From:
Monks Orchard Residents' Association
Planning

11th February 2019
Emails: planning@mo-ra.co
chairman@mo-ra.co
hello@mo-ra.co

Reference: 19/00219/FUL
Application Received: Thu 17 Jan 2019
Application Validated: Wed 30 Jan 2019
Address: 2 Round Grove Croydon CR0 7PP
Proposal: Demolition and erection of a two-bedroom two storey dwelling with associated amenity space, car parking, storage and cycle storage
refuse
Case Officer: Victoria Bates
Consultation Close: Sat 23 Feb 2019
Deadline determination: Wed 27 Mar 2019

Fig 1 – Proposed Elevations

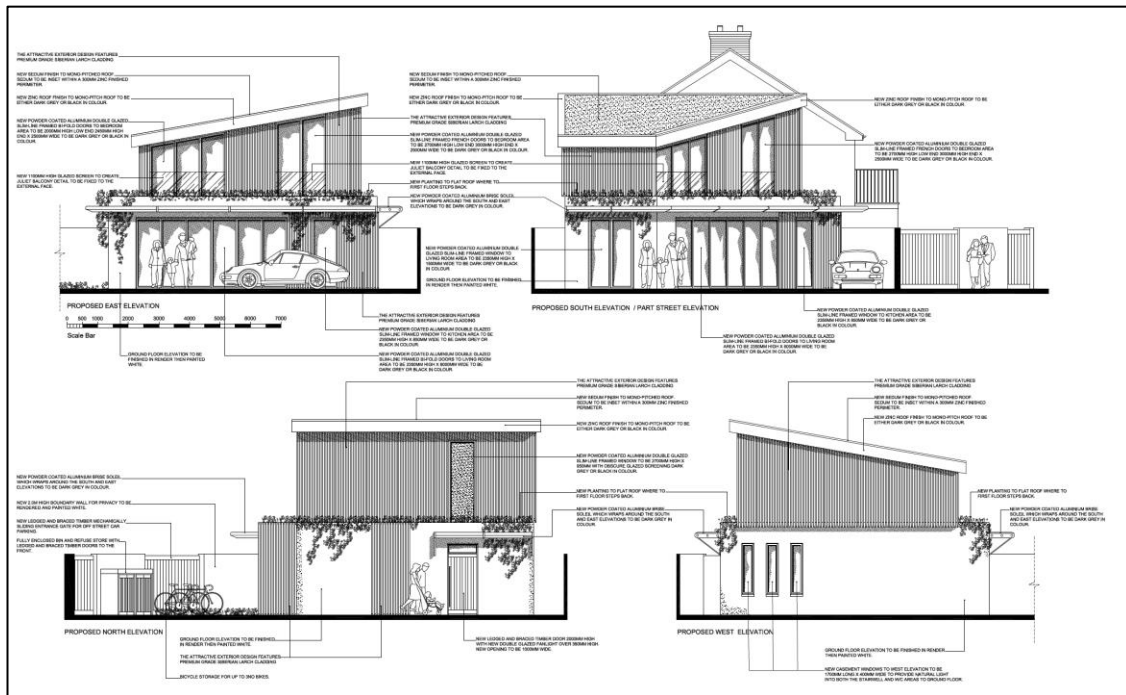
The Proposed development does **NOT** respect the locality or have regard to the **form, function, and structure** or physical connection with the **local features** of the locality, place or **street scene**, and does not reflect the **scale, mass and orientation of surrounding buildings**. In fact, the proposed structure would be **totally out of character with surrounding dwellings** by the obvious architectural characteristics proposed.

This design proposal is completely out of character with the surrounding dwellings.

We therefore **object** to the **architectural design** of the proposal as **totally inappropriate** for **this locality at this time** as the **predominant character defines the area of pitched roofs and conventional build structures of brick buildings and conventional tiled roofs**. This structure does **NOT** blend or **enhance the local character of the Shirley Place**.

The proposed development **roof form** is completely different in **structure** and **visual appearance** to the roof forms of the surrounding dwellings and buildings and therefore does **NOT positively contribute to the character of the local and wider area.** It is **NOT sympathetic with its local context** and therefore is **non-compliant** to **Policy DM10.7 d).**

The proposed development does **NOT respect, enhance or strengthen local character** as the proposal is of an **entirely different architectural design** to that of the **predominant local character** as is shown at **Fig 1 and Fig 2** above and therefore is **non-compliant** to **Croydon Plan Policy 10 Design & Character Policy 10.9 a).**

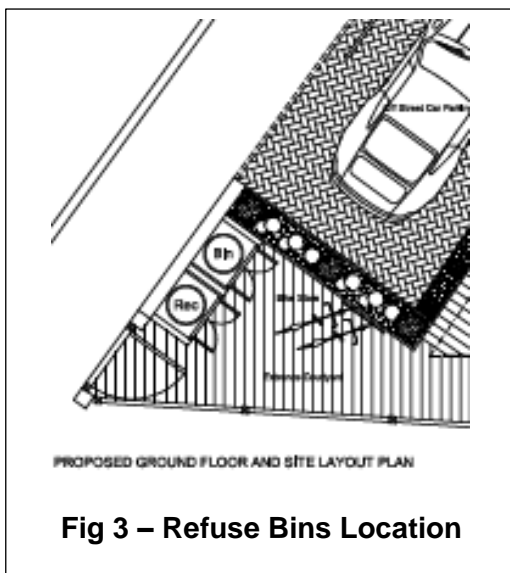
Each residential dwelling is supplied with a **240-litre wheelie bin** for mixed paper and card and a **180-litre wheelie bin** for general rubbish and an **additional bin provided for recycling glass, plastic packaging, cans and cartons**. An optional **Green Waste bin** for garden waste may also be required. There is only storage space for **two refuse bins** for this proposed development. Therefore, we contend that the provision is **woefully inadequate** and does NOT meet the requirements of **Policy DM13: Refuse and recycling.**

The positioning of the refuse bins are not located behind the building line and is therefore in contravention of **Policy DM13.1 a).**

The access gate opens **wrong handed** as, when open it actually blocks access to the refuse bins and makes for awkward removal of the bins for refuse operatives. If the Bins are to remain at this location the gate should have the **reverse handed opening** so that when opened, the gate is level with the south boundary wall allowing full access to the bins.

Fig 4 – Parallel Parking reversing – attempting to reverse into the Parking Bay

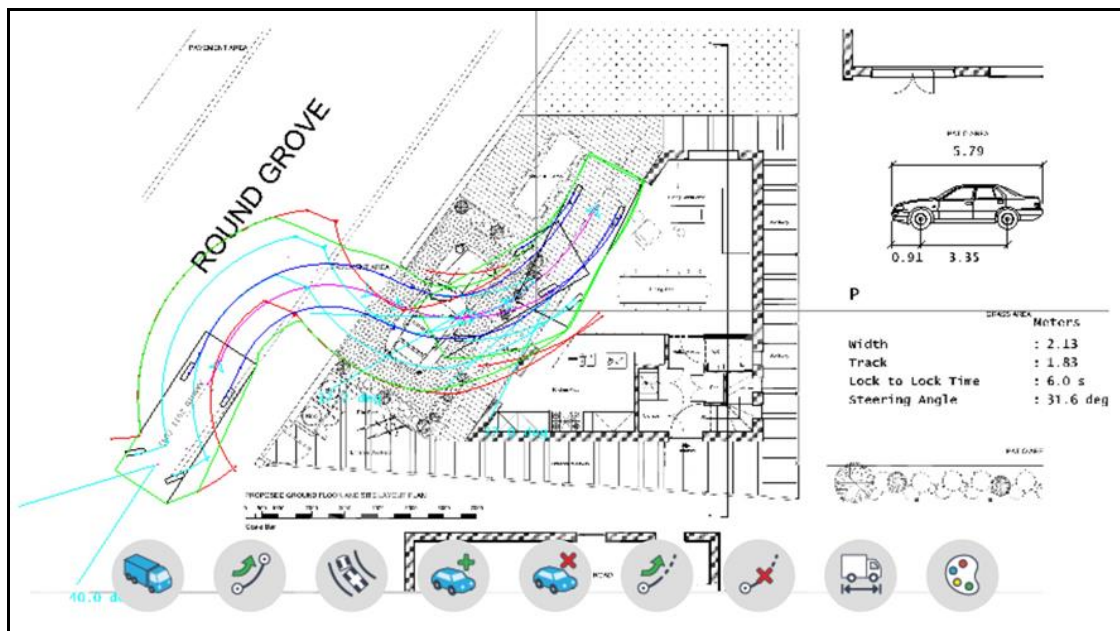
The parking bay shown is 5.5m x 3.2m and if the sliding gate is taken into account the bay width would be reduced to 3.0m. The maximum width of the entrance into the bay is shown as 3.5m. However, the sliding entrance gate is shown as stopping at the left-hand flower bed so the gate will be projecting 1.5m into the entrance space thus reducing the width of the entrance to 2.0m. If this remains the case it would be impossible to park a car in the parking bay, other than a 'Smart Car' or similar and the only feasible method would be by a parallel parking manoeuvre, reversing into the bay (not in a forward direction as illustrated on the proposal plans).

However, even if the gate completely slides back so that the full 3.5m entrance is clear then, although possible to park a Smart Car or equivalent into the bay, family cars, estate cars and mid-size SUV's will **not** be able to park without undertaking two, three or even more parking manoeuvres, reversing and forwarding (See Figure 4).

The standard parallel parking bay on a highway is generally 6.0m x 2.4m and most cars should be able to park in this space. However, the highway bay is open for the full 6.0m length and generally cars in the adjacent bays are not parked tight to the ends of the adjacent bays. Therefore, this makes reverse parallel parking easier. Also, the road width – even with double parking - allows full lock arc to gain access in a reverse direction.

Fig 5 - Entering from a Northerly Direction (not Possible in one manoeuvre)

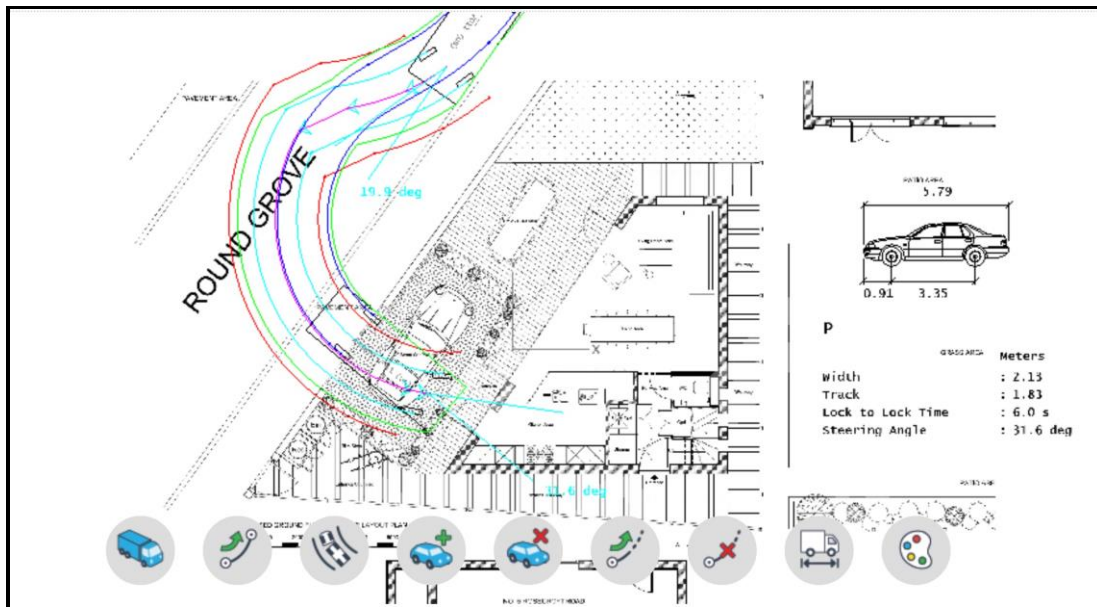
There is no turning facility and the swept path for entering and exiting this hard stand area is not provided on the plans and is considered to be an exceedingly difficult – or probably an impossible manoeuvre. If entering in a forward gear, in order to position the front of the vehicle within the car hard stand area, the front offside would likely encroach over the offside border area and the protruding edge of the sliding gate would foul the nearside passenger doors. (See Fig 5 & 6).
